October 1, 2012

Re: Longhorn Pipeline Reversal – LMP Changes

# **Attachment #1**

# **Attachment #2**

### East Houston to Crane 18" Pedernales River Basin

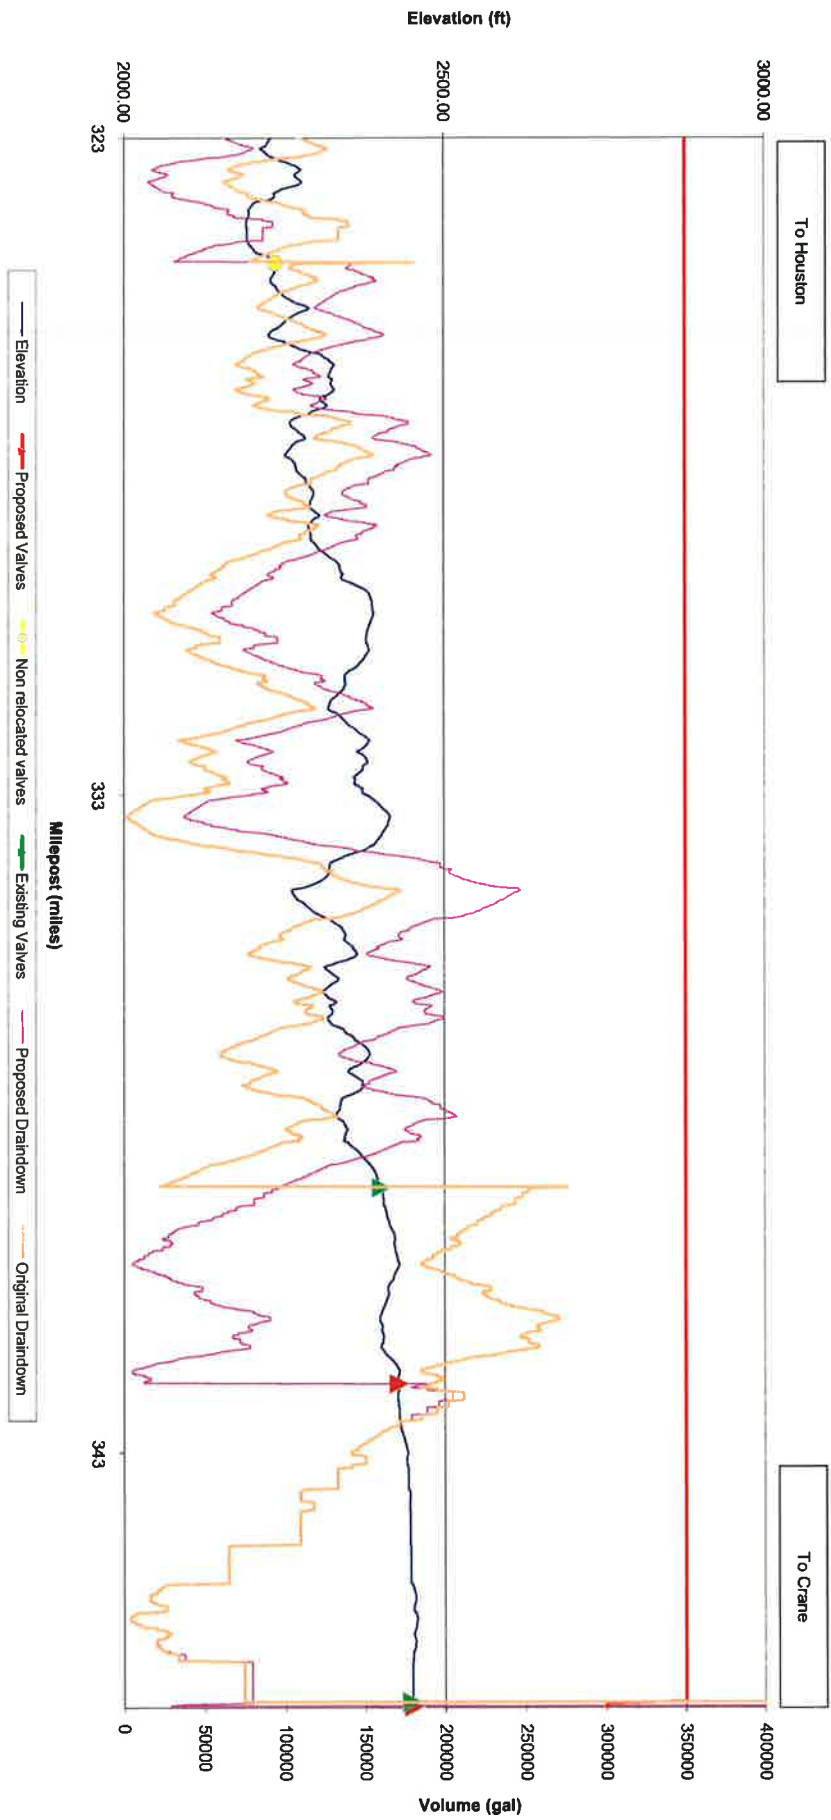
Magellan proposes to remove the check valve at MP 205.5. Magellan had originally proposed to move this valve west to Station MP 204.8. Various issues led to a second proposed site; however, an evaluation of the drain down volumes shows no benefit by moving a valve to this location over complete removal of the valve. Potential drain down volumes affected by these modifications will remain below maximum drain volumes as specified within Mitigation Appendix Item 22. All valves will be in place and functional prior to initiating crude flow from Crane to Houston. Magellan has reviewed these modifications with the Lower Colorado River Authority and they have indicated that they do not oppose to these changes.

The following table summarizes Magellan's proposed plan to replace or relocate currently installed check valves specified by Mitigation Item 22. See Attached Drain

down Summary (Attachment #1) and Drain Down profiles (Attachment #2) illustrating changes to drain down associated with the new locations.

Pedernales		Existing Max	Proposed Max Drain	Settlement Max
		drain down (gal)	down (gal)	Drain down (gal)
	Between start of basin and CV3	103,533	40,942	200,000
	Between CV3 and CV10	103,657	84,365	200,000
	Between CV10 and MP 198.64	114,141	109,178	200,000
	Between MP 203.44 and CV6*	80,634	155,082	200,000
	Between CV6 and CV7	55,830	132,750	200,000
	Between CV7 and End of Basin	136,472	136,472	200,000

\*Proposing to remove CV11 based on drain down profile
